APPLICATION NUMBER: 25/1004

PROPOSAL: DEMOLITION OF BUILDINGS AND CONSTRUCTION OF 6NO DWELLINGS, ACCESS ROAD AND ASSOCIATED WORKS

SITE: Kensington Court Day Centre, Oaklands Road, Newport

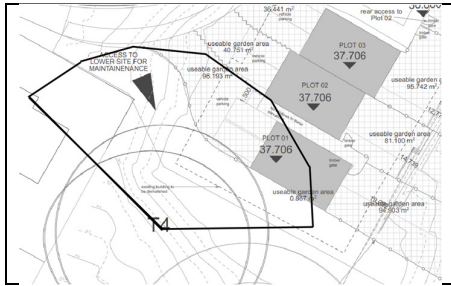
Previous applications showed crib wall sections at an overbearing height to the rear of plots 2 and 3 (similar to the proposed house ridge height). For this application, this has been reduced to a more human scale of max 3m height but it is not clear how this change has been achieved - there is a significant discrepancy from previous applications as shown below.

Are levels beyond the site in neighbouring properties accurate? Topographic information which the site needs to tie into is not made available.

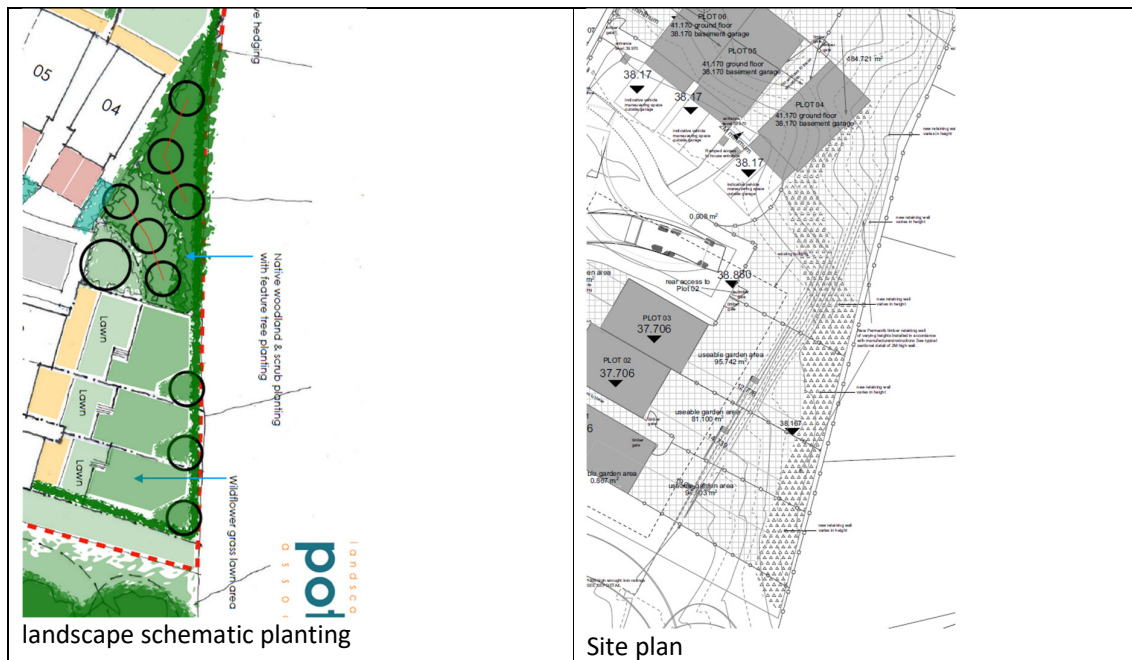
Plot 1 dwelling and front garden area will be in shade for part of the day – the tree shadows from an earlier 2023 layout should be translated onto the revised site plan. Appreciating that tree T4 is on lower ground, I have shown a quick overlay for the revised site plan, note that shade will still affect dwelling rooms and front garden planting.
